Planning Commission Staff Report

Subject: 30 Sampson Avenue
Project #: PL-12-01487
Author: Mathew Evans, Senior Planner
Date: June 26, 2013
Type of Item: Conditional Use Permit – Ratification of Findings

Summary Recommendations

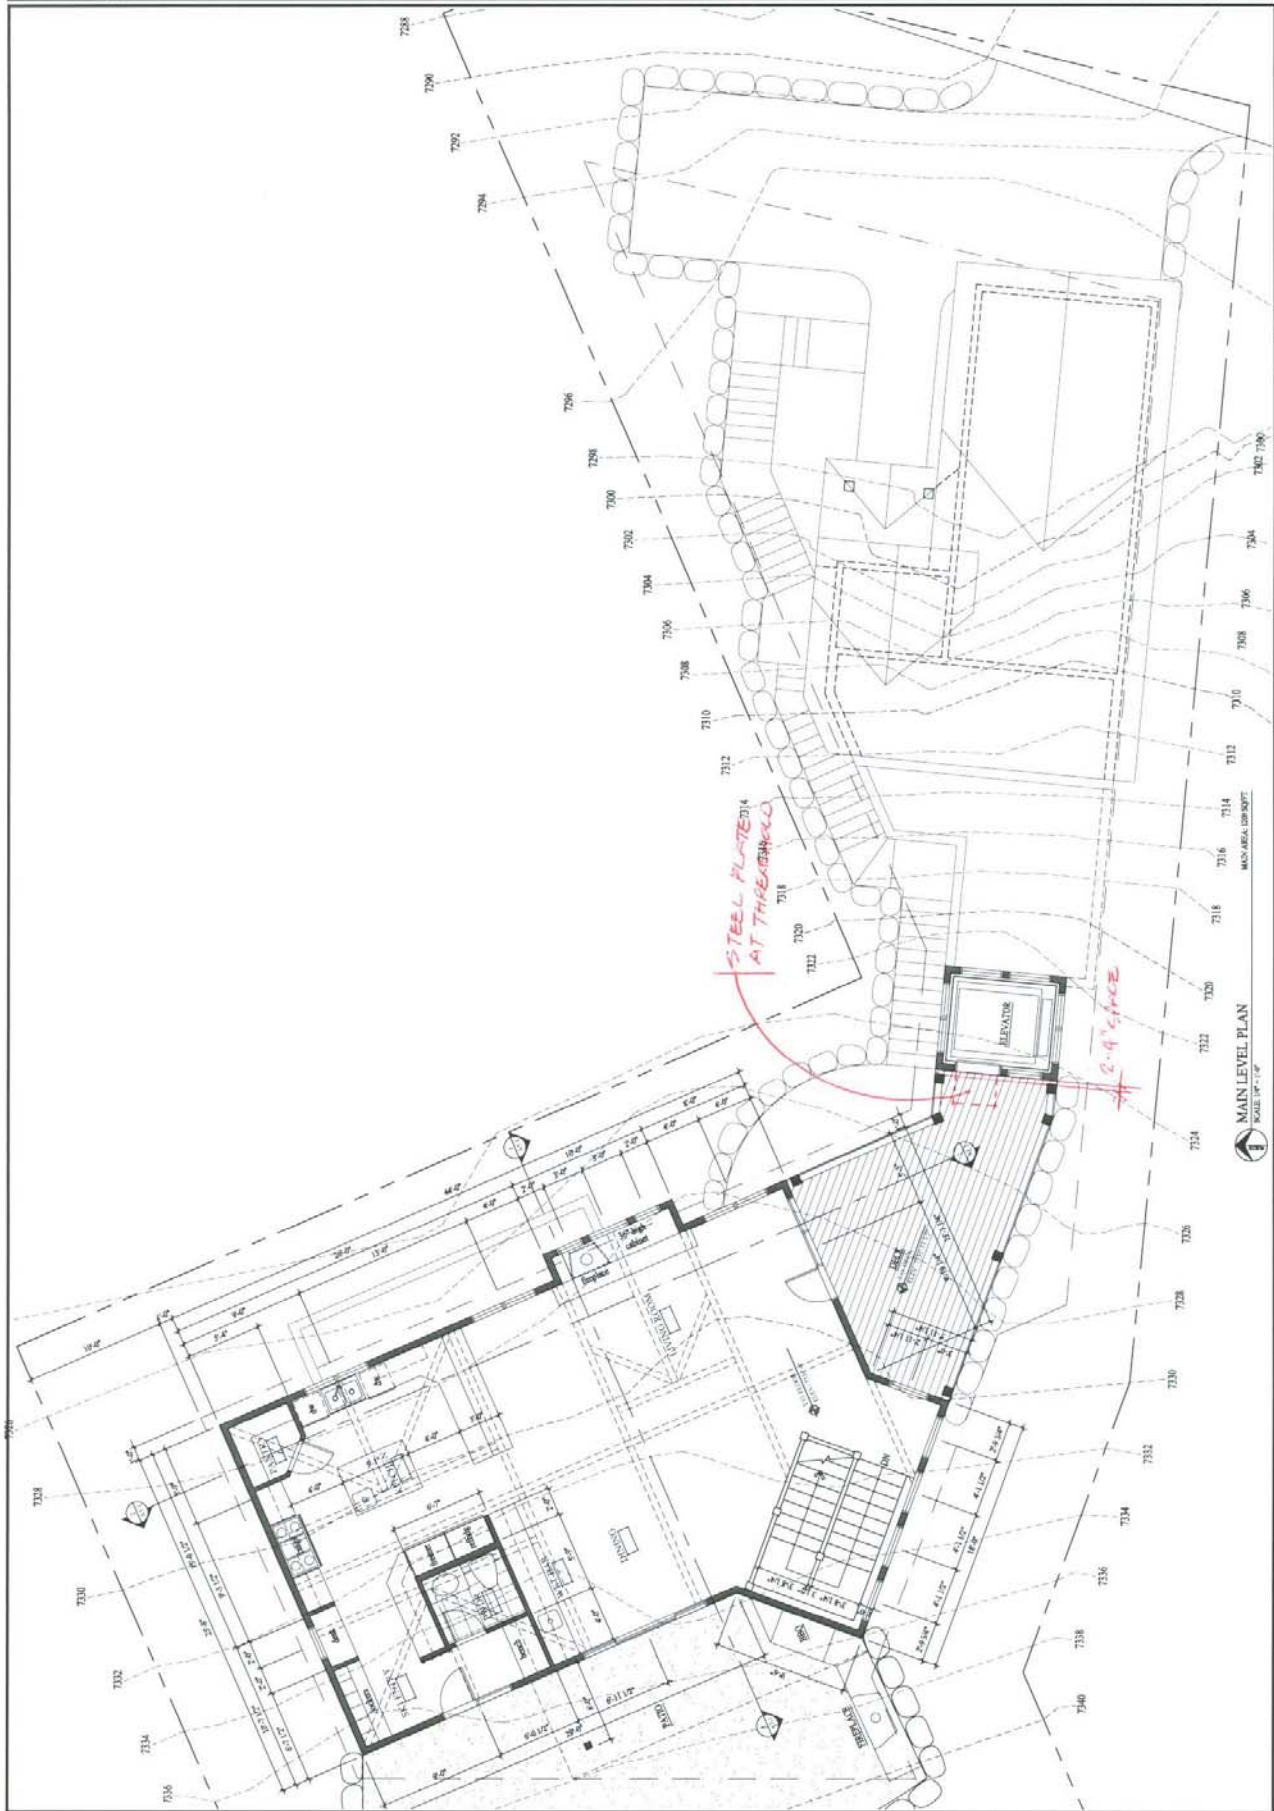
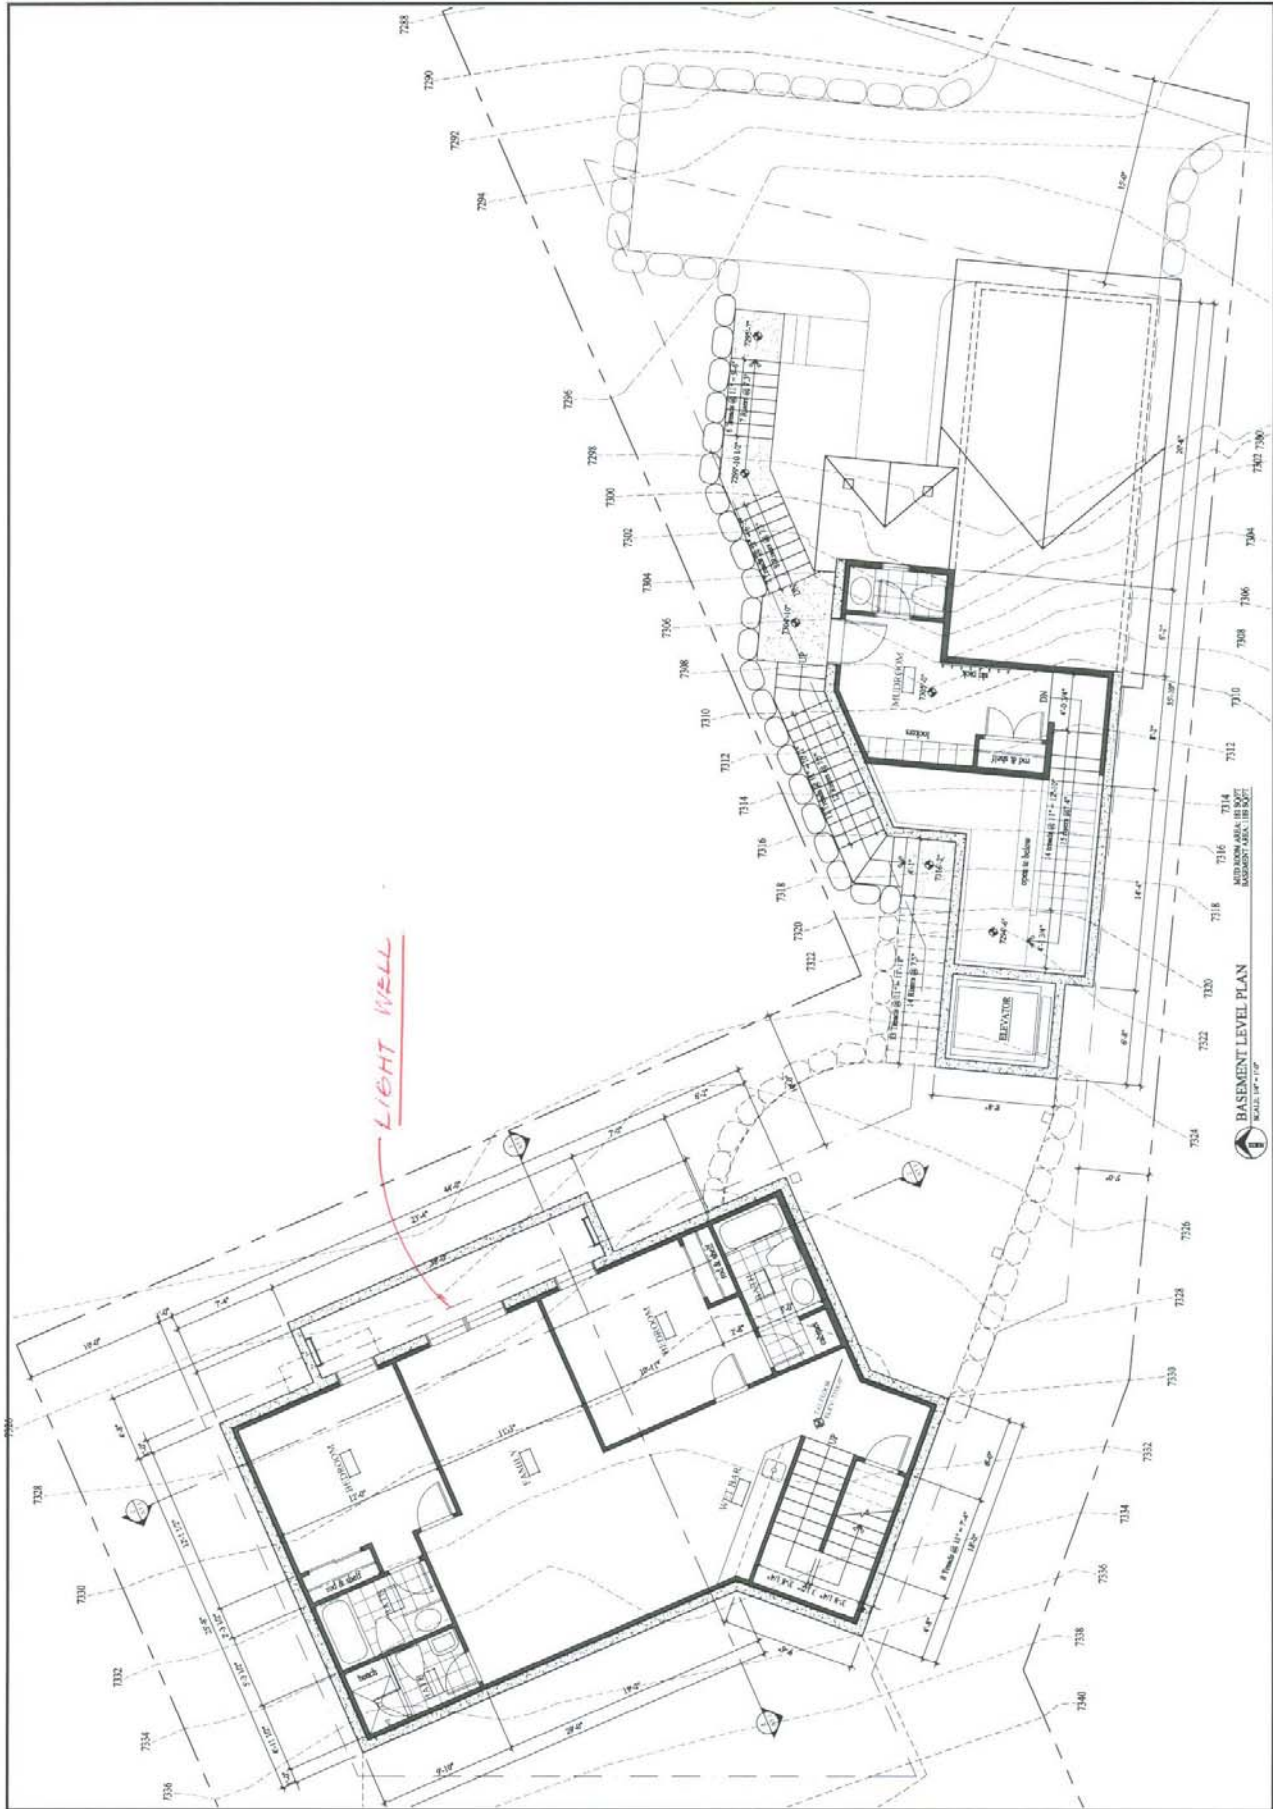
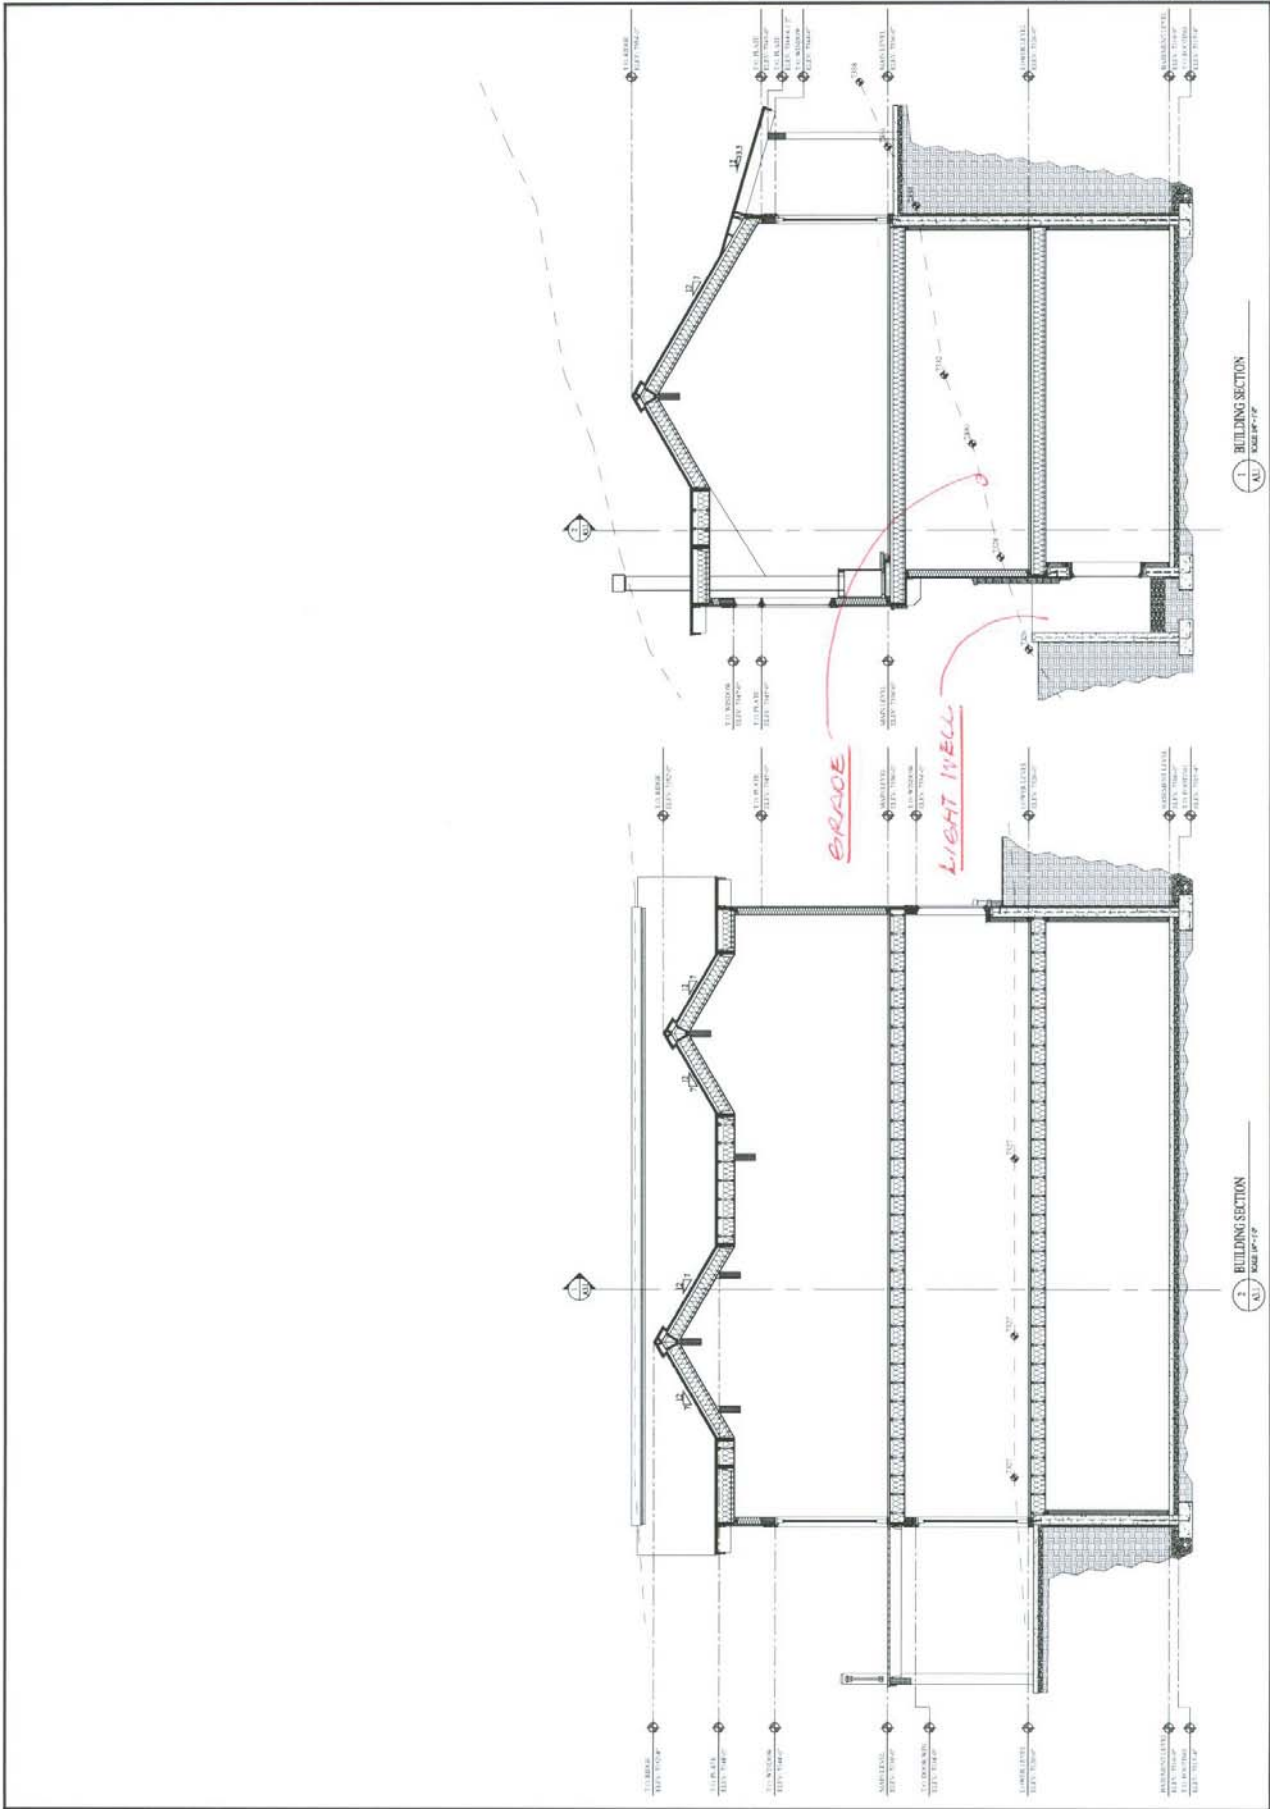
Matt,
I had also asked Chad to review the light wells for compliance. His response is below.
Thanks,
Jon

After looking at your revised set of plans you have separated the structure into two separate structures per the classification under the Building Code since the deck is no longer being supported by the elevator. Also you asked about the basement and with the light wells it is still considered a basement under the building code with the light well. You could have the light well all the way around the basement and it would still be considered a basement. If you have any questions please feel free to give me a call. 435-615-5115.
